Responses to the consultee feedback, planning application #201876

Blewgarth, The Warren, Caversham, Reading, RG4 7TH.

Demolition of existing buildings and erection of replacement boathouse and leisure building with associated access and landscaping

Summary of changes - plan view

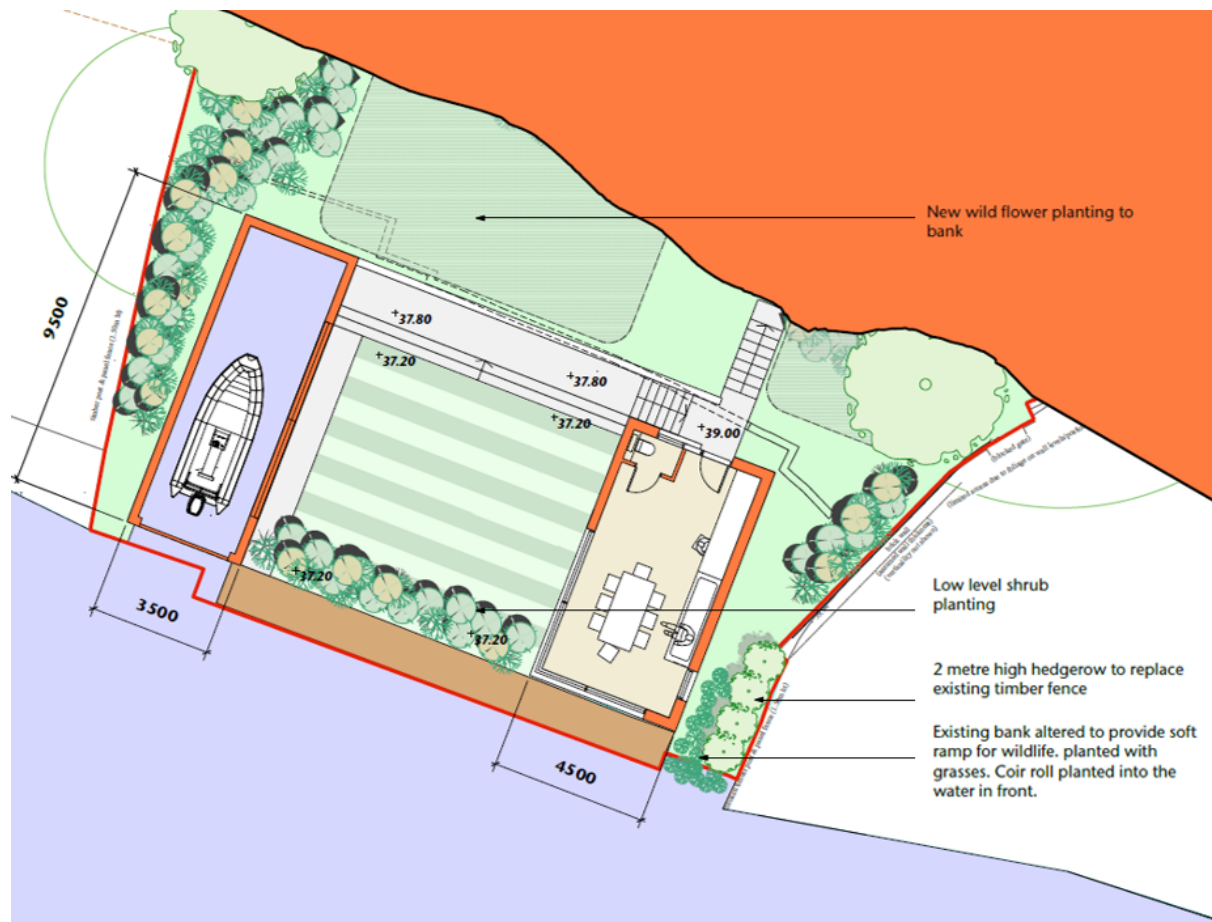
The revised scheme encompasses modifications to the flood design system of the building, a significantly increased planting scheme in order to ensure a net increase in biodiversity, whilst also softening the outline of the summer house building, blending it into the landscape. In summary, the amended scheme now includes:

1. Modification to the flood void area covering, providing a total of 4 large openings (each 1.5m in width) with 2 on each of the east and west facing walls (shown in figure 1), following consultation with the Environment Agency, in the interests of aligning with the latest guidance on flood compatible design. We have retained the perforated brick design to the front of the building, providing additional flood compatibility, beyond what the guidance requires.

2. Establishment of a natural soft bank, approximately 1.8 metres in width on the far-east side of the existing concrete mooring area.
3. The addition of coir rolls in front of the natural bank area, to provide a fish refuge, in the interests of increasing biodiversity.

4. Planting of wildflowers and shrubs across the sloped bank, covering approximately 30% of the site. The bank is steeply sloped towards the river and hence is visible from the south side of the river. The planting will make a positive contribution to the view of the site.

5. Planting along the edge of the river margin, between the boat house and summer house, in order to further blend in the new buildings.

6. Planting of hedging, c.4 metres in length, 2 metres in height, replacing the proposed panel fence to the south-east corner, adjoining the canoe club. The hedge will provide both improved ecology and soften the visual impact of the new summer house building from the east, including from Caversham Bridge (c.0.5KM to the east)
7. Addition of 2 new bird boxes and 1 bat box to the buildings to further enhance site ecology.

Figure 1: adjustended flood compatibility design includes large openings covered with metal bars, spaced at 100mm. The height of the openings is 38.67M, the design flood level. The width of each of the openings is 1.5M.

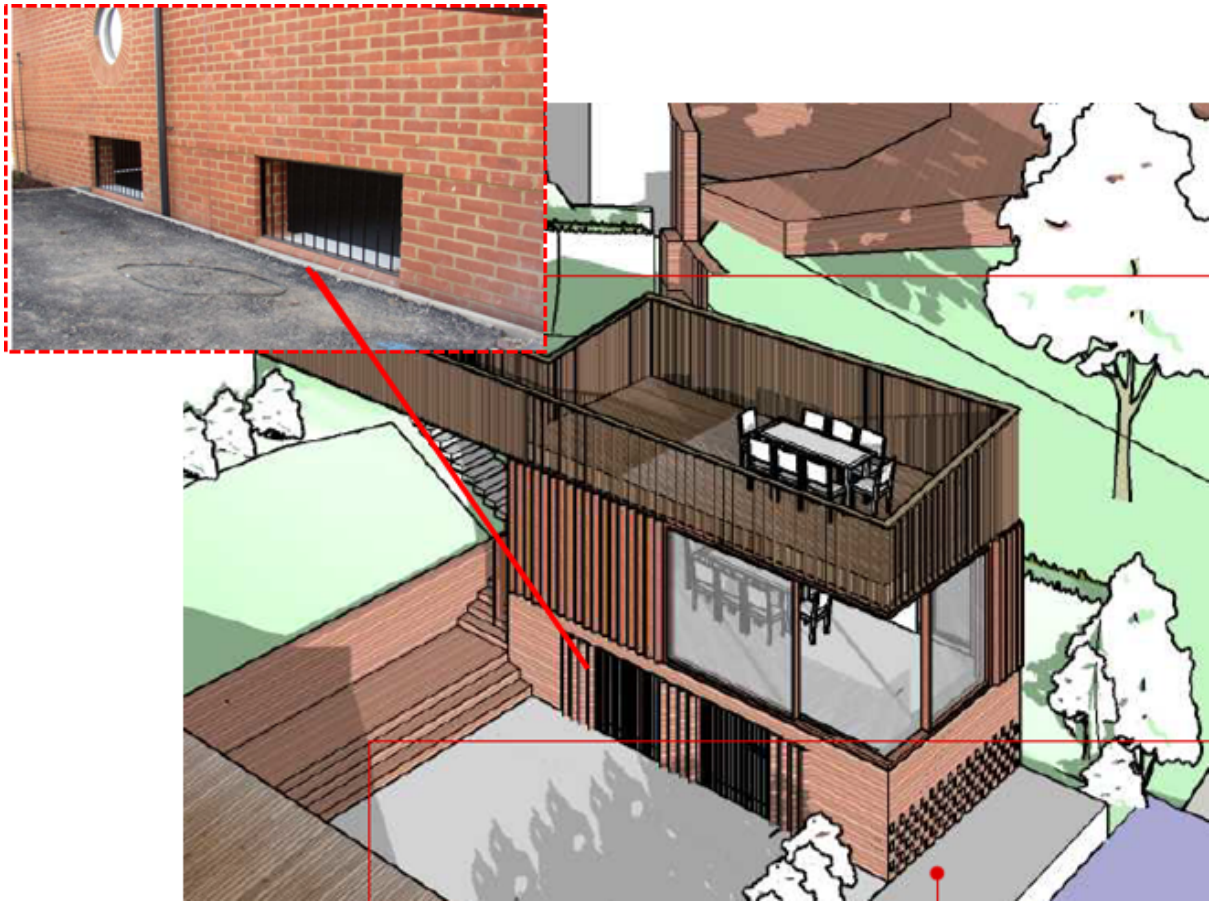
- c. We noted a concern from the EA regarding the choice of flood void covering (perforated brick). Following consultation with the EA, we have modified this design to also include large openings on the east and west facing walls (in addition to the perforated brick at the front). This is shown in figure 1 in this letter and within the updated drawings. The email correspondence with the EA confirming this is also attached as a separate file. The flood voids are 1.5 metres in width each (6 metres in total) and set at the height of the design flood level.

Figure 2: Approximate area of flood area shown in shaded blue.

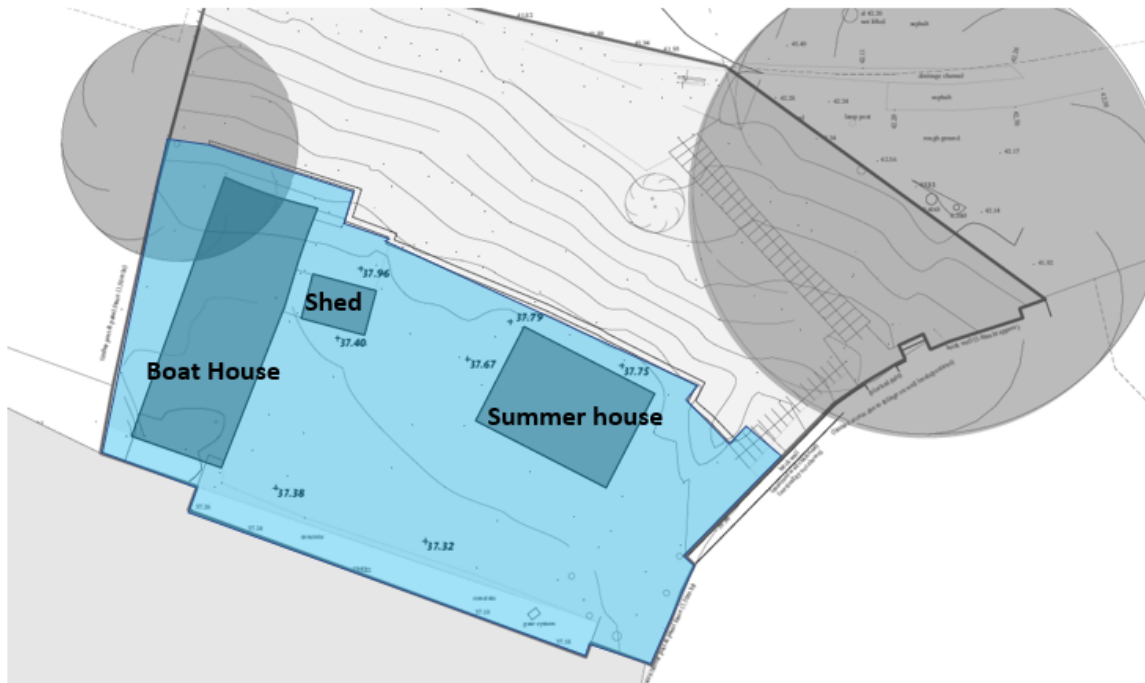
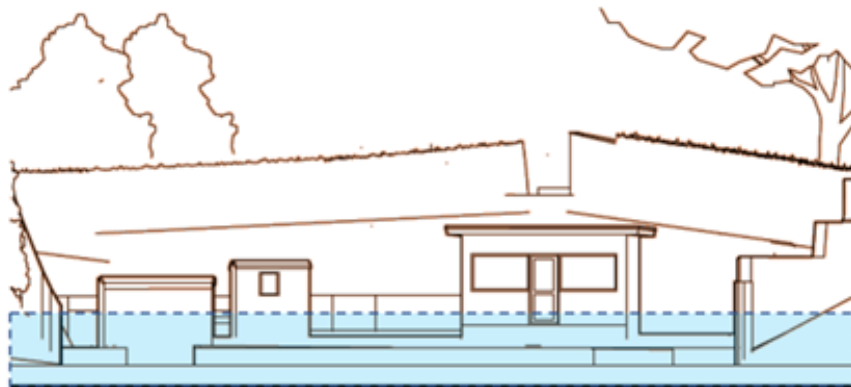
- a. We confirm that the shed - and all areas forward of the retaining wall (including summerhouse, wet dock and shed on the current site) reside within the design flood area and are hence included within the net flood storage calculations. These are identified on page 26 of the FRA.

- b. We can confirm that a net increase of 84 cubic metres of new flood storage area will be created as a result of the improved building flood compatibility; reduction of soil level within the flood area and restoration of wet dock.
